**MONTE VISTA WATER DISTRICT
NOTICE TO PLANHOLDERS**

ADDENDUM NO. 2

Project: Plant 30 Wellhead Treatment

From: Hazen and Sawyer

**120VAC INSTRUMENT
RISER DIAGRAM**

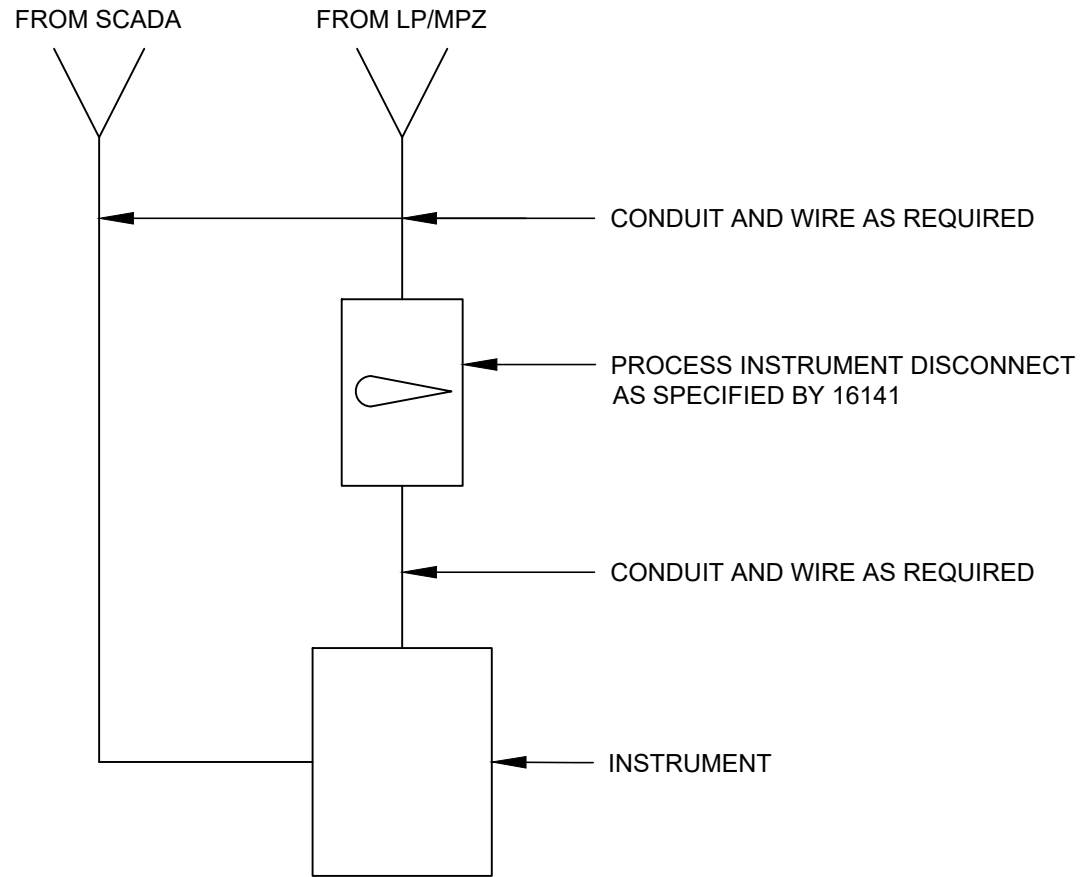
Addendum 2, ITEM 64. QUESTION: Please provide a mounting detail for the process instruments disconnecting means. That will be located throughout the site in various types of locations. Are these disconnecting means required for Motor Operated valves and Flow Control Valves? Enclosure type? This series "NSSC" is not available in the material specified below.

ANSWER: See riser in the attachment. Process instrument disconnects are not required for valves. Process instruments are primarily located outside, and the enclosures shall be NEMA 4X SST or equal.
